Town of Stallings Resurfacing Project FAQ

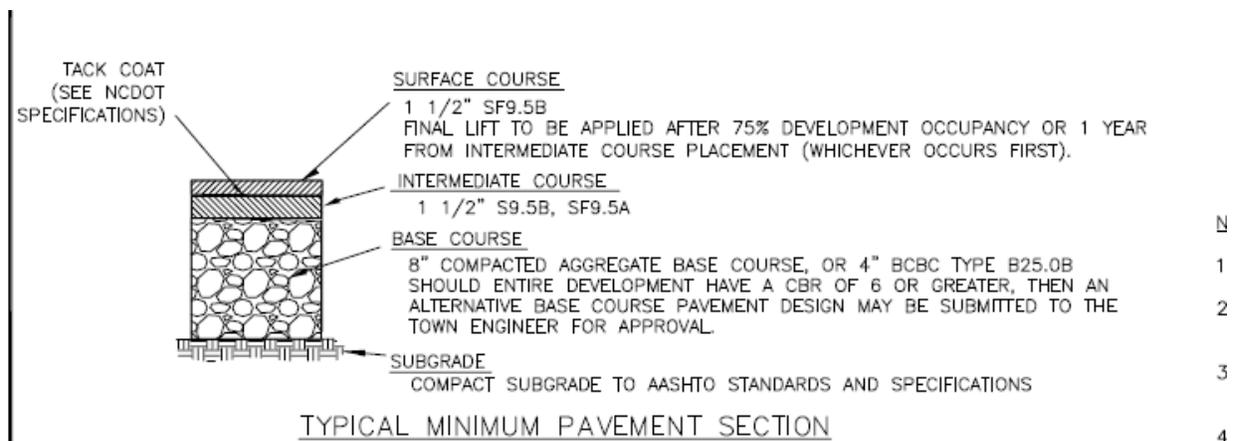
Can you provide some more information on Item 8 - Reconstruction? What is that for?

Answer: **Reconstruction encompasses removing the subgrade and implementing our typical pavement section (please see following snip):**
